Access Compliance Report Public Rights-of-Way (Curb Ramps)

Main Street: N/A Cross Street: SENDERO_WAY Location: E

ADA ID: RPRK211122124642 Ramp Type: Type 6 - Directional 1 Initial Pass/Fail: Pass Overall Compliance: No Severity Score: 5

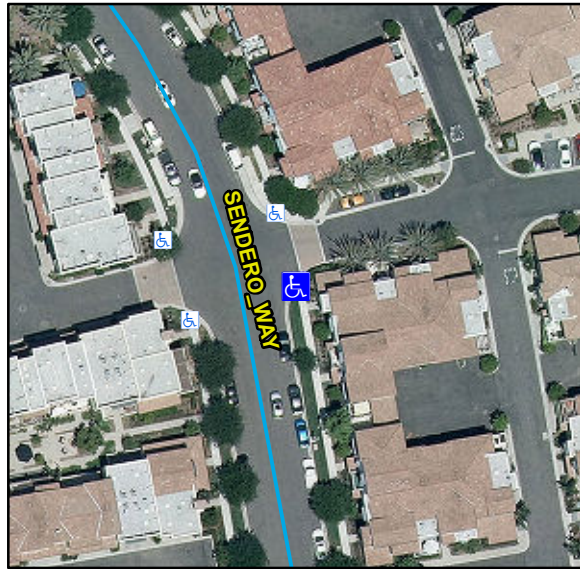
Marked Crosswalk 1 Width (in)	N/A			
N/A	Ramp Inside Crosswalk 1	N/A			
	Crossing 1 Slope (%)	5.4			
	Crossing 1 Cross Slope (%)	2			
Yes	Gutter Ponding	No	Yes	Curb Slope	3.2
Yes	Gutter Lip Height (in)	0		Road Run Slope (%)	N/A
No	Gutter Run Slope (%)	9.8		Road Cross Slope (%)	N/A
Yes	Gutter Cross Slope (%)	1.3		Parallel Ramp Side	Left
Yes	Overall Surface Condition	Acceptable	Yes	Perp Joint Present	Yes
	Cross Gutter Present?	No		Spandrel Present?	No
	Replace Cross Gutter?	N/A		Replace Spandrel?	N/A

Remove & Replace Gutter.

R304.5.4, STD 1115
